Below is the list of 13 variances required as listed in staff memo for zba hearing on 15 dec 2021. Revisions to the proposed design make 6 of the variances no longer required. The 6 variances that are no longer required are shown with a strikethrough.

V1-
MORE THAN ONE
PRINCIPAL BUILDING
ON ONE LOT

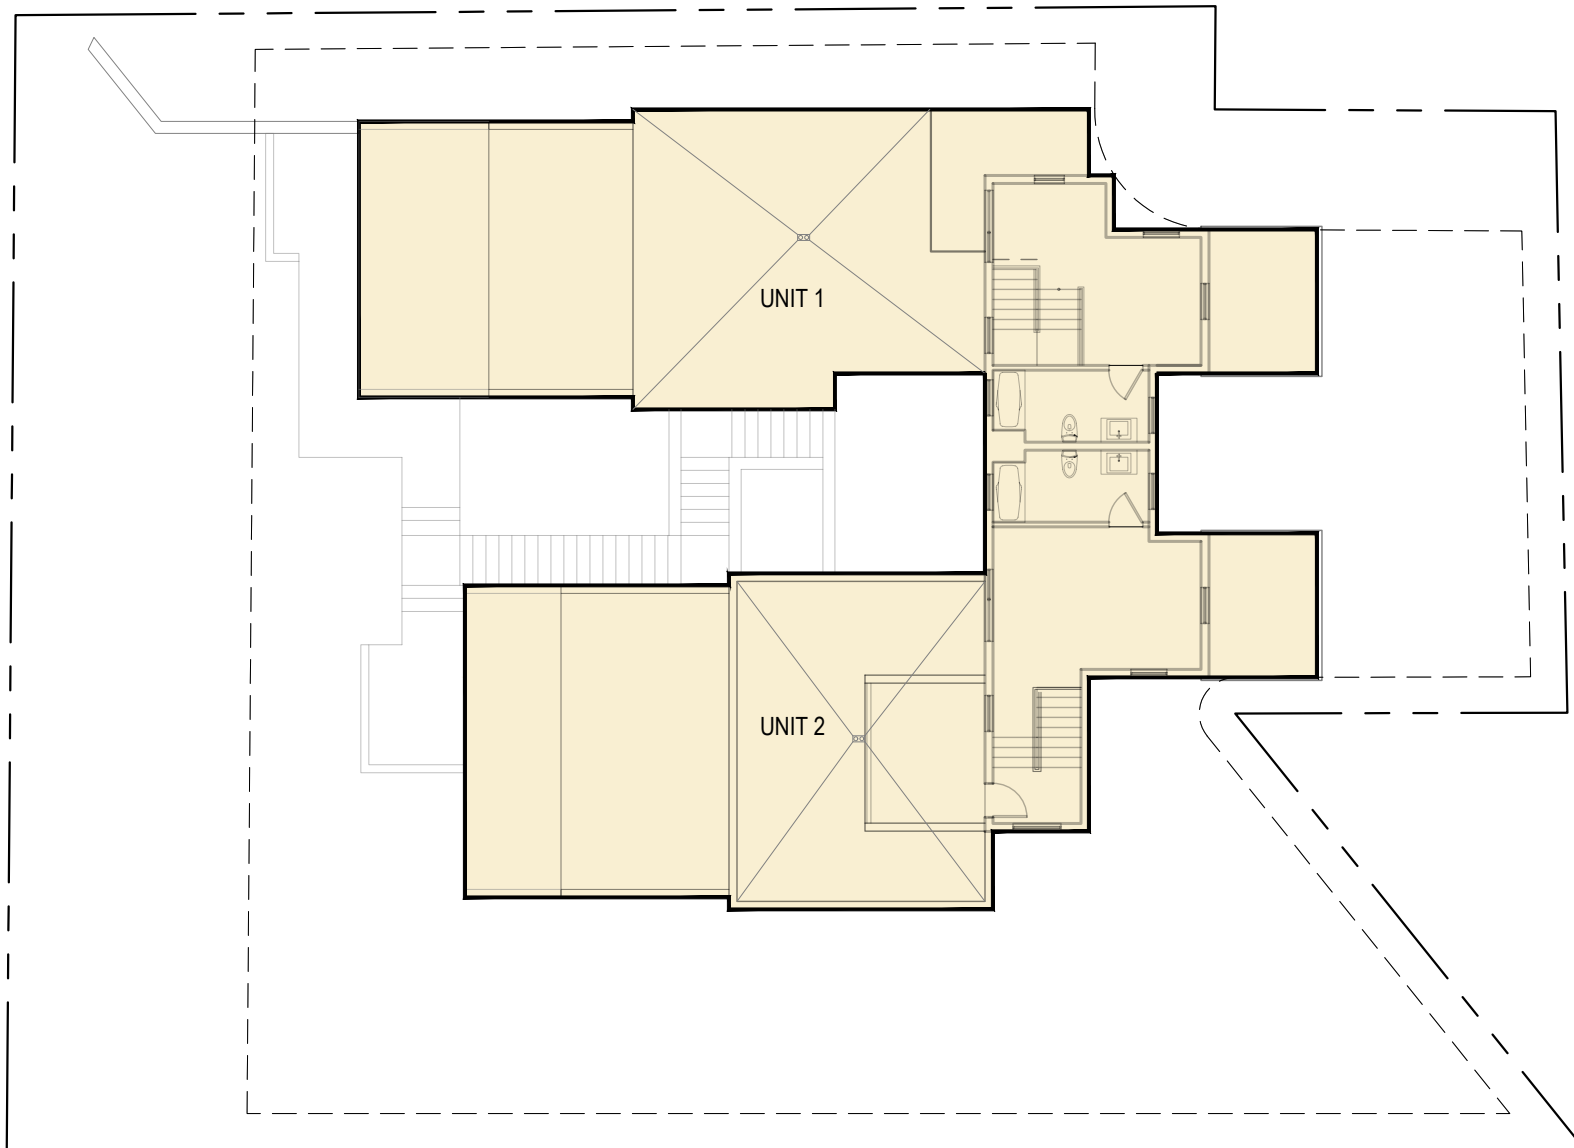
A VARIANCE FOR HAVING MORE THAN ONE PRINCIPAL BUILDING ON LOT IS NO LONGER REQUIRED, BECAUSE THE REVISION JOINS THE TWO UNITS WITH A CONNECTOR TO FORM ONE PRINCIPAL STRUCTURE.

NO LONGER
REQUIRES RELIEF

V2-
BUILDING TYPE

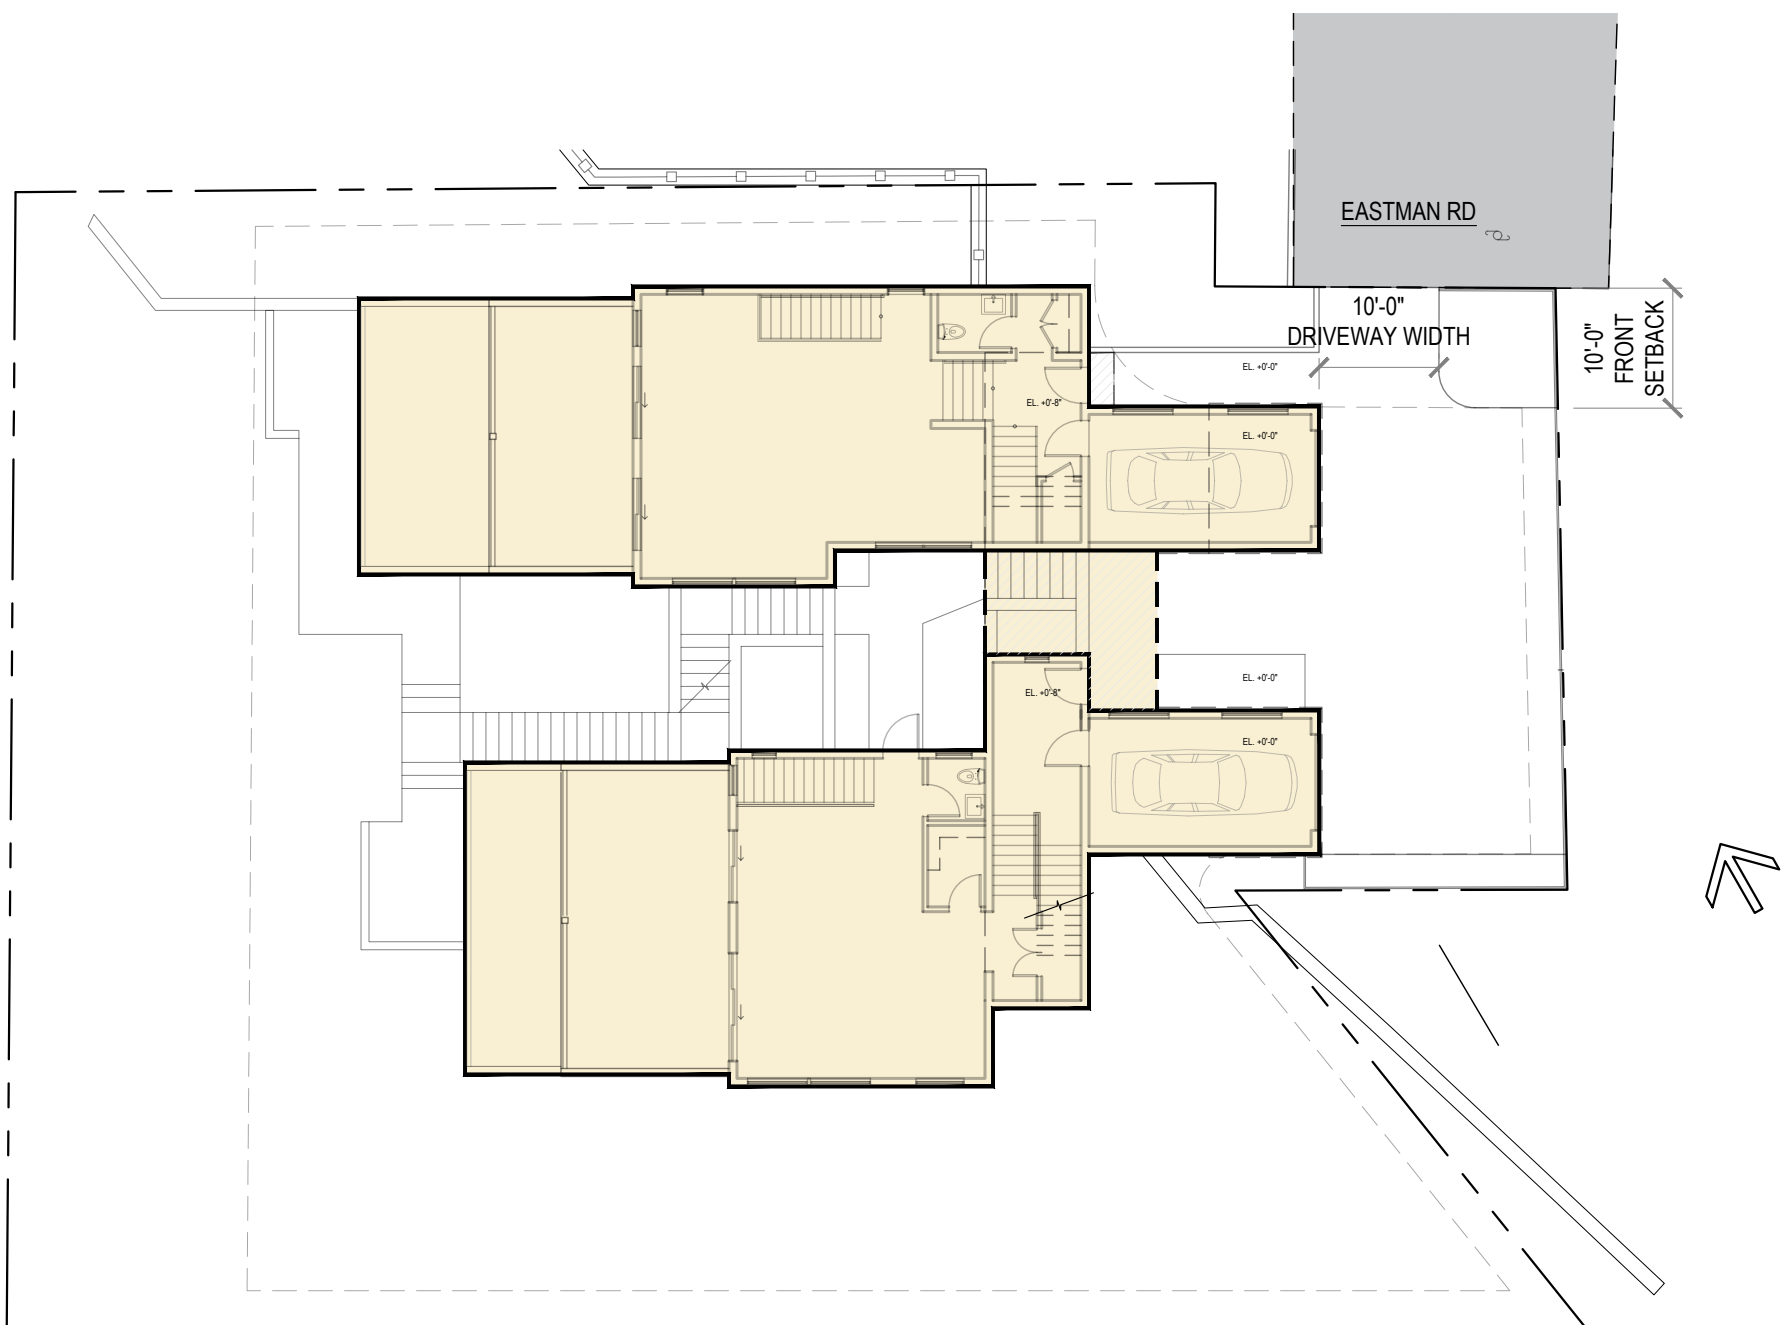
BUILDING TYPE REQUIRES RELIEF, BECAUSE THE PROPOSAL PLACES THE UNITS BESIDE ONE ANOTHER RATHER THAN STACKING ONE OVER THE OTHER. THIS IS NECESSARY IN ORDER TO HAVE A LOWER TOP HEIGHT MADE POSSIBLE BY STEPPING THE BUILDING DOWN THE SLOPE.

REQUIRES RELIEF

V3 -
DRIVEWAY IN
FRONTAGE AREA

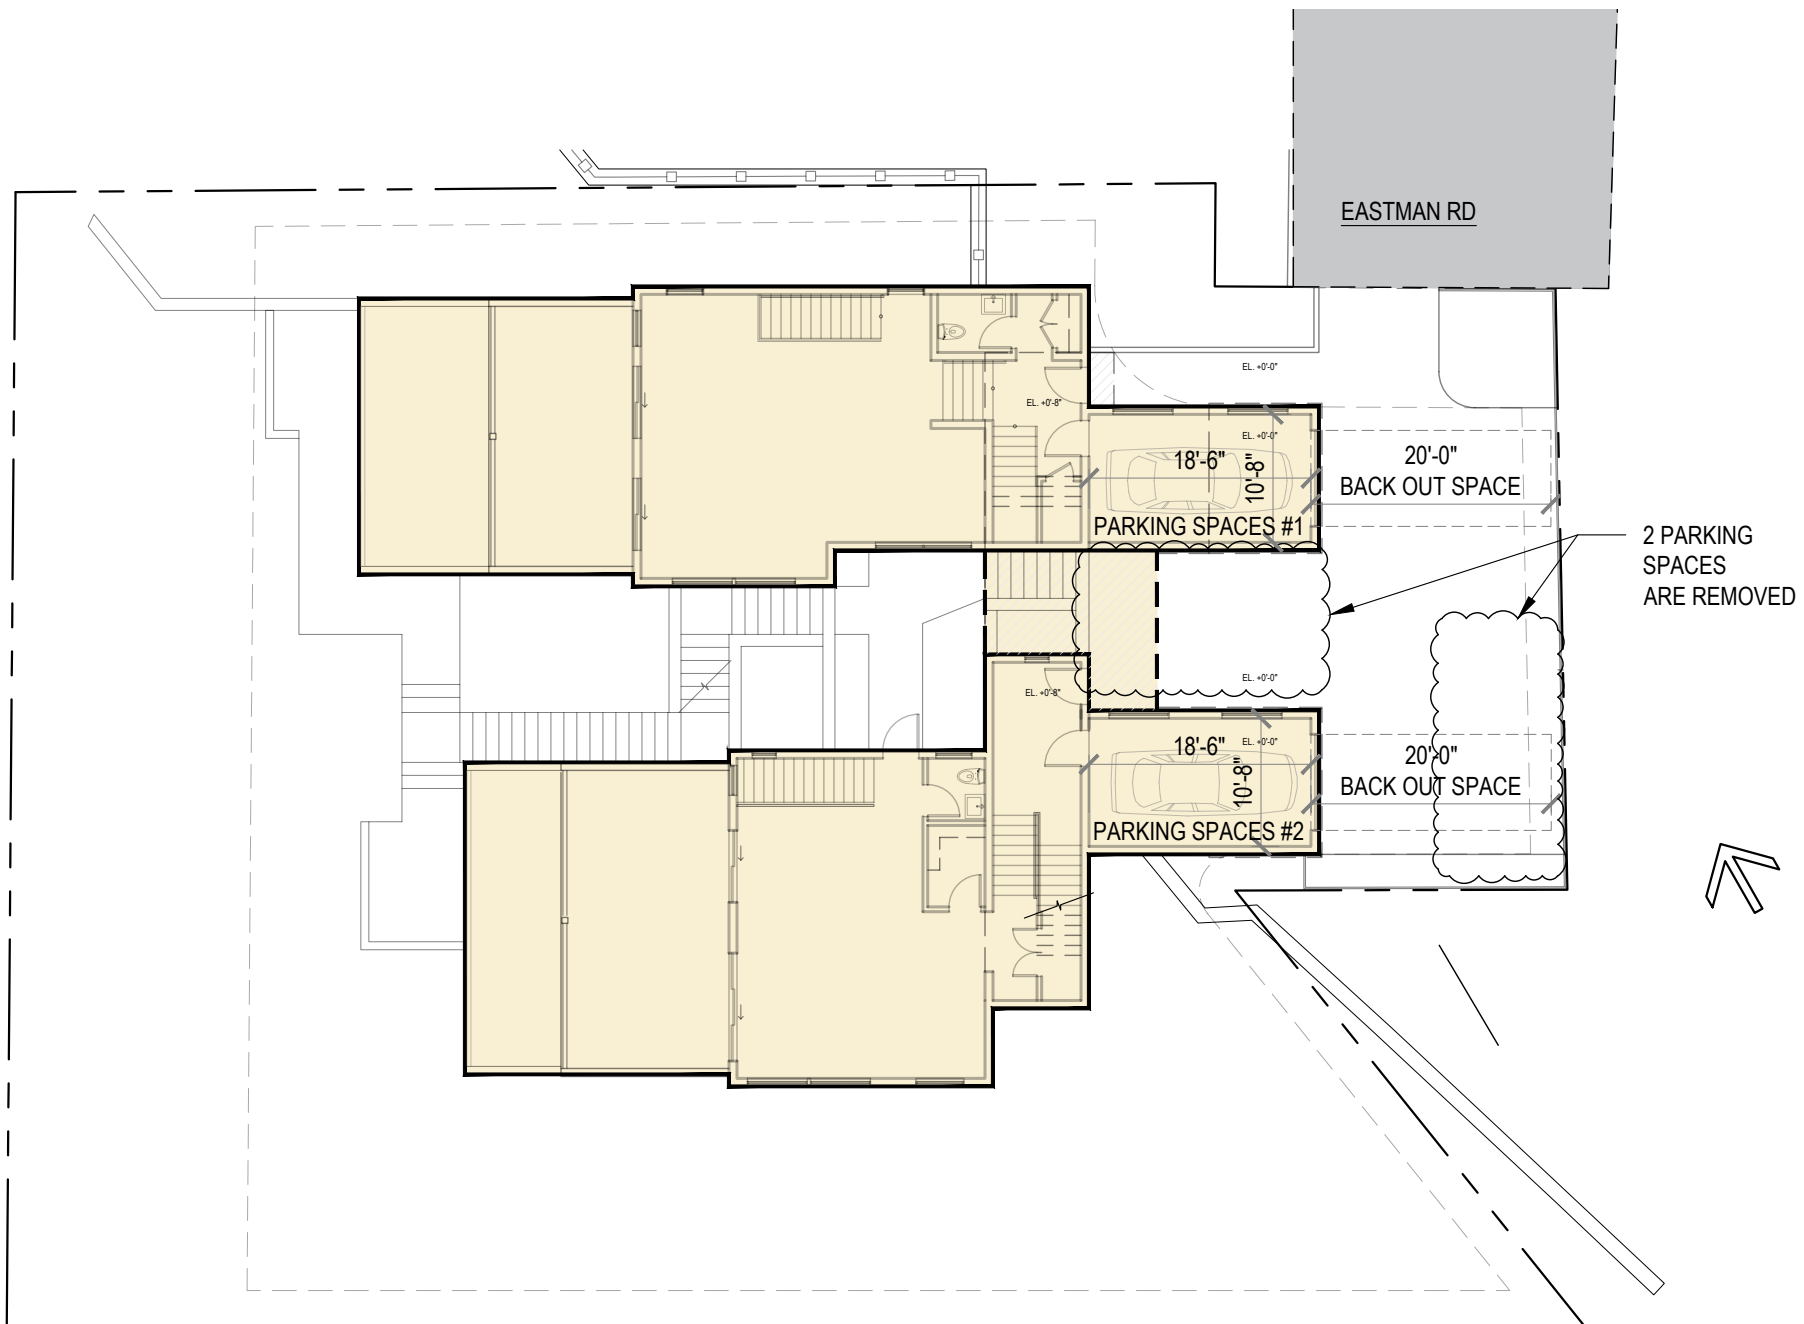
DRIVEWAY IN FRONTAGE AREA NO
LONGER REQUIRES RELIEF,
BECAUSE THE REVISION LIMITS THE
DRIVEWAY TO 10' IN WIDTH.

NO LONGER
REQUIRES RELIEF

V4 - PARKING SPACE AND DRIVE AISLE

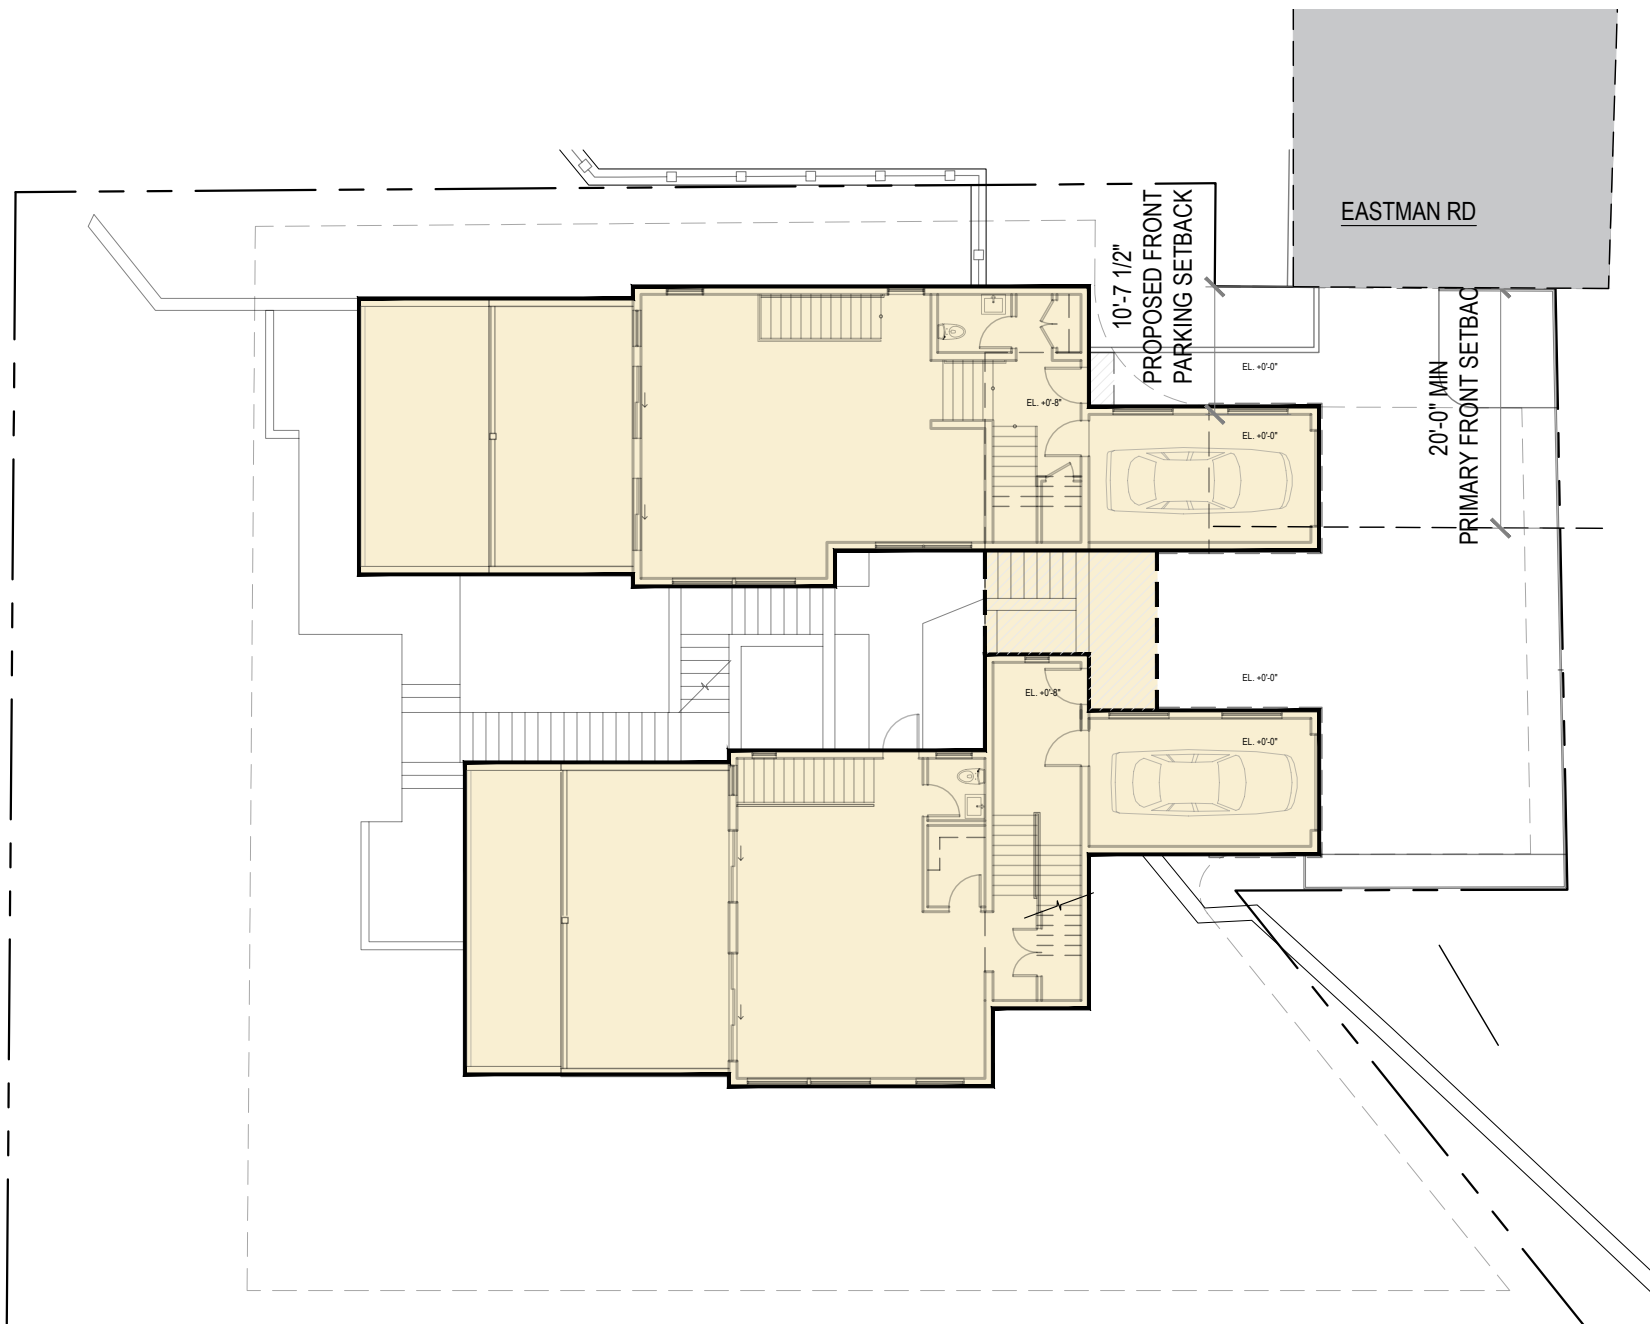
PARKING SPACE AND DRIVE AISLE NO LONGER REQUIRE RELIEF, BECAUSE THE REVISION REMOVED THE 2 PARKING SPACES THAT PROHIBITED THE REQUIRED BACKOUT DISTANCE.

NO LONGER REQUIRES RELIEF

V5 -
PARKING IN
FRONTAGE AREA
REQUIRES RELIEF

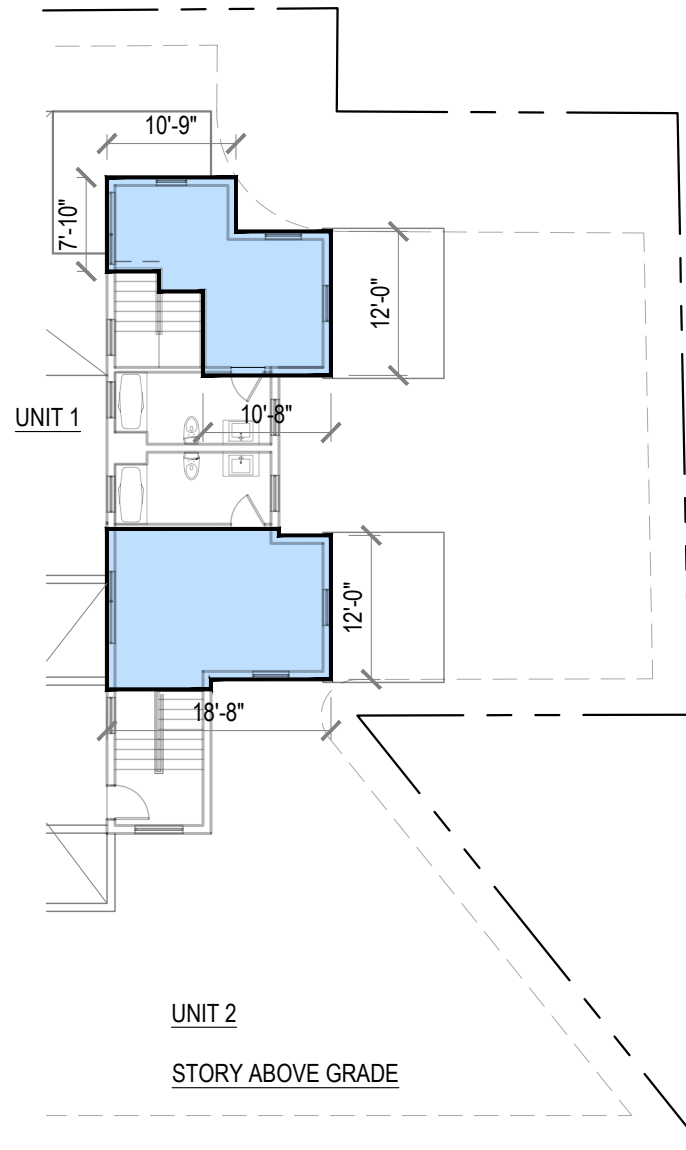
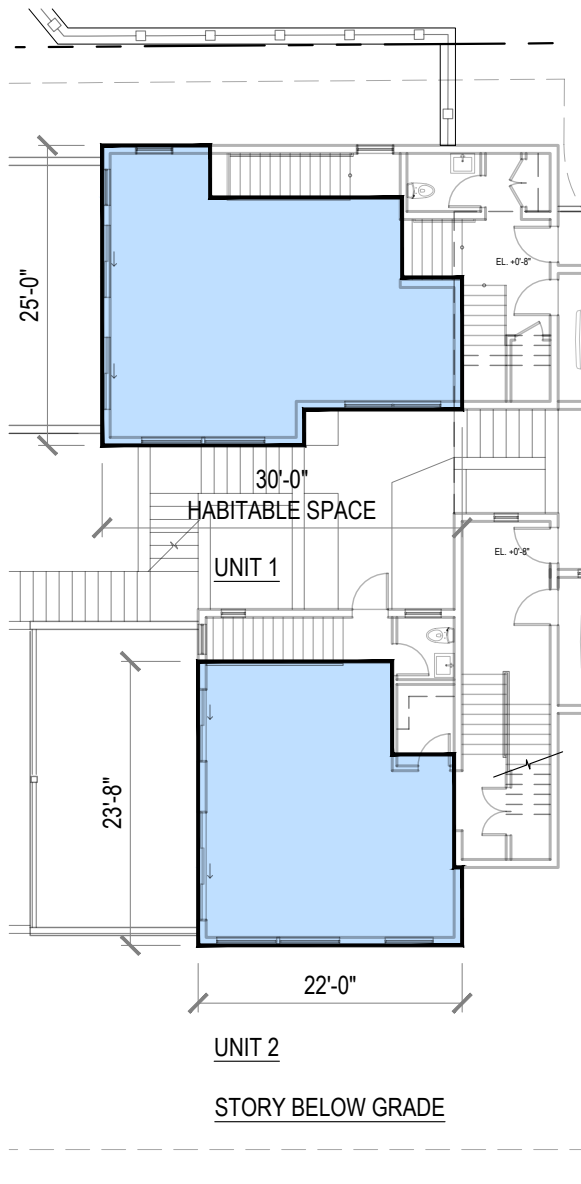
PARKING IN FRONTAGE AREA
REQUIRES RELIEF, BECAUSE THE
PARKING SPACE FOR UNIT 1 IS IN ITS
GARAGE, WHICH IS WITHIN THE 20'
MINIMUM PRIMARY FRONT SETBACK.
